Elevation Plans_V1.pdf Markup Summary

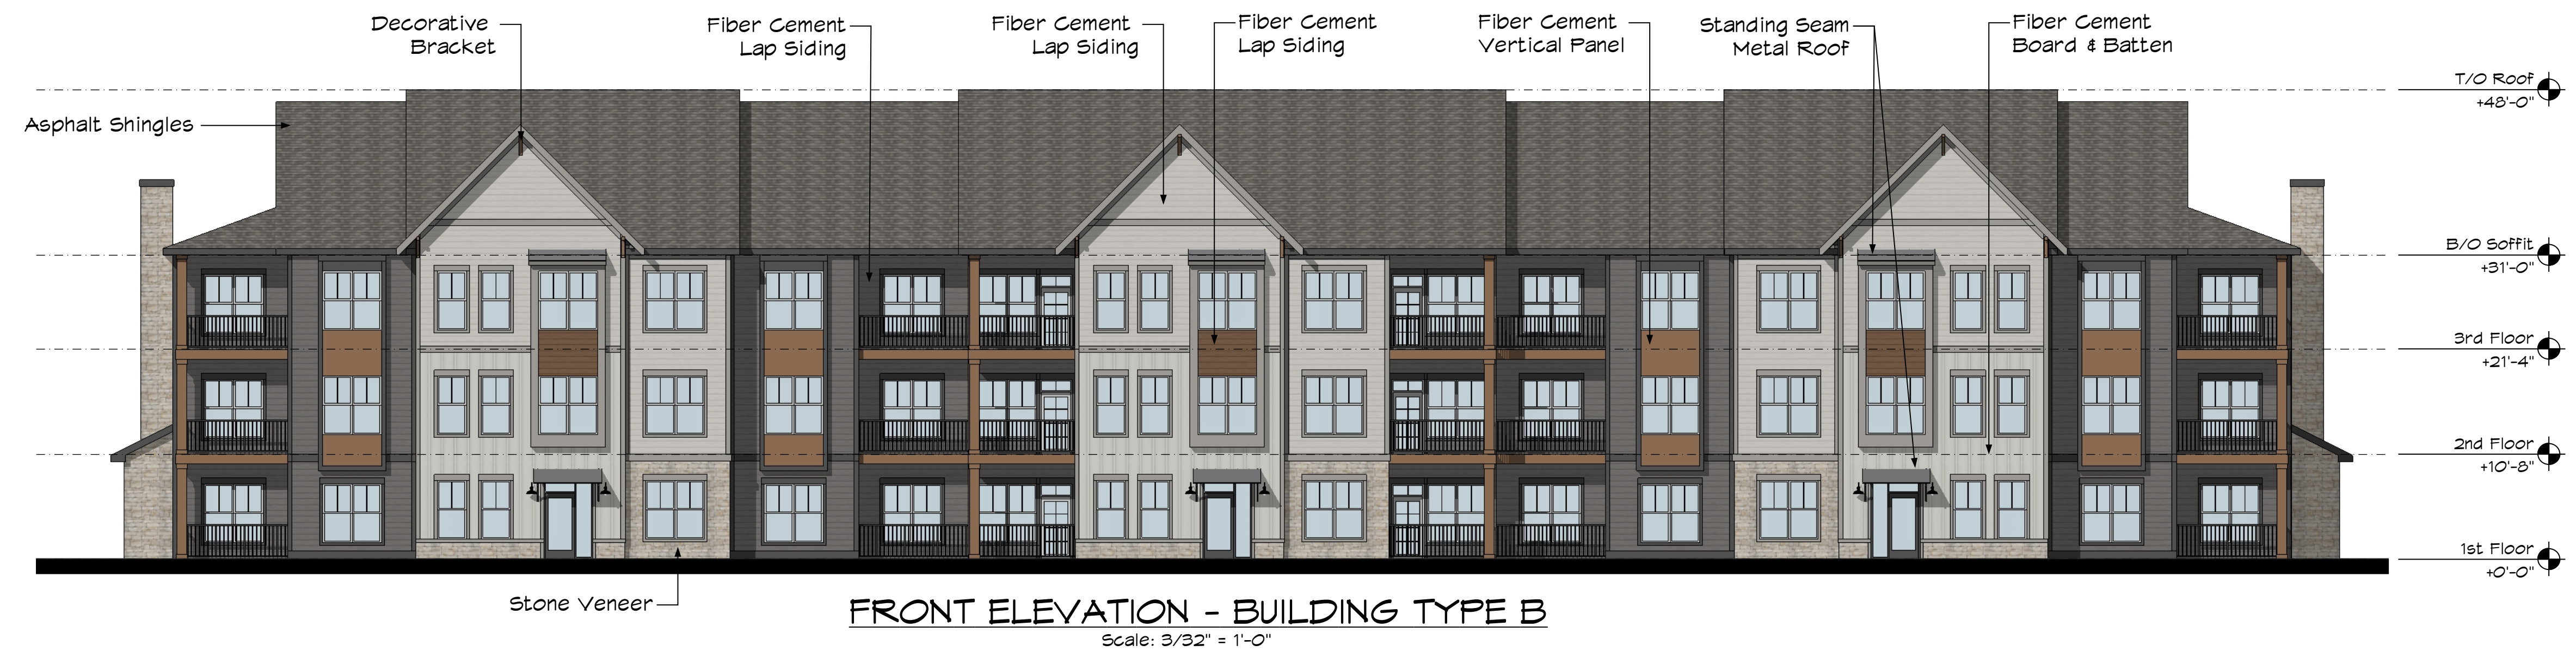
Because allowed building height is max. 40 height, please show the average roof height to demonstrate that the 48' to top of roof-line still meets the height limitations.
